Planning & Zoning Board

Thursday, November 7, 2024

Summit Crossing – Major Site Plan, Preliminary Plat, Variance Requests

H-2

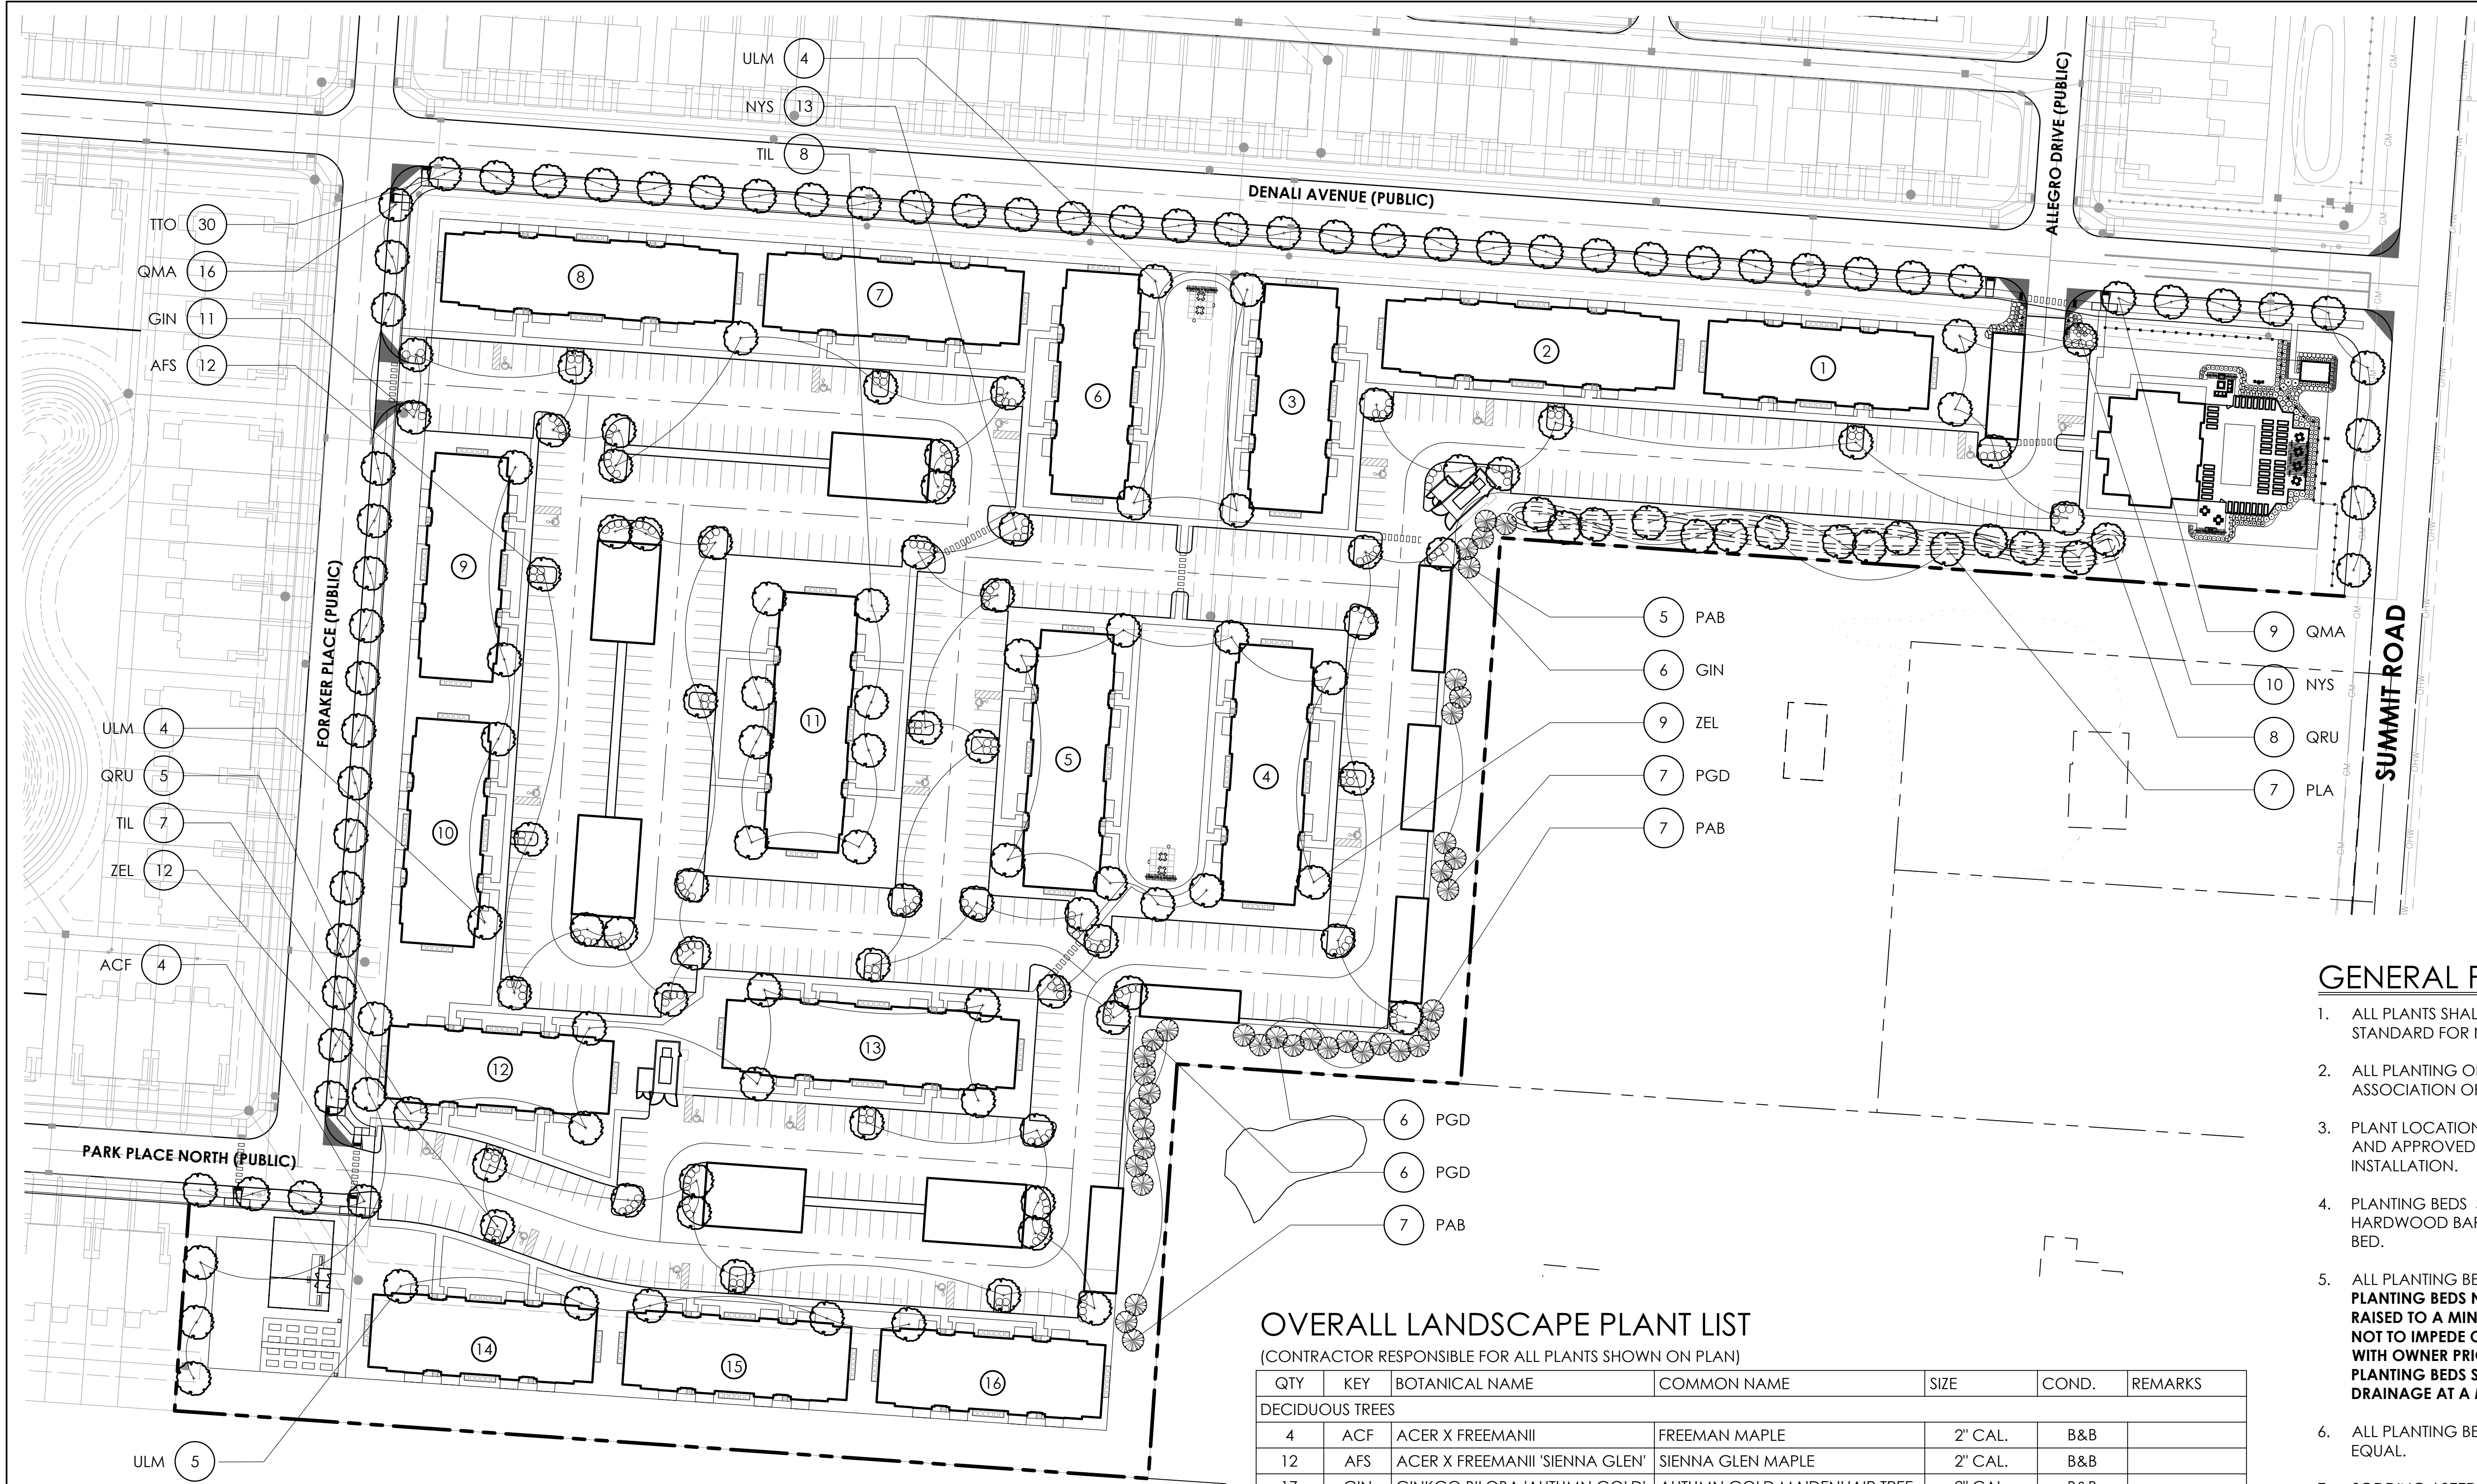
60. On sheet H-2, please change under Tree Replacement not, minimum caliper of (1.75") to 2".
Since it now states 2 inches instead of 1.75 inches due to a recent code update. Section 1105.07.E

61. On Sheet H-2, for Street Trees, it appears to be short 5 large trees, if you are doing large trees at a maximum of 45 feet apart. Please correct the number of street trees provided on the site.
Section 1105.07.G

63. Add the number 38 to evergreen trees at 6" GHT. In the "Parking Area Berm" section on sheet H-2.
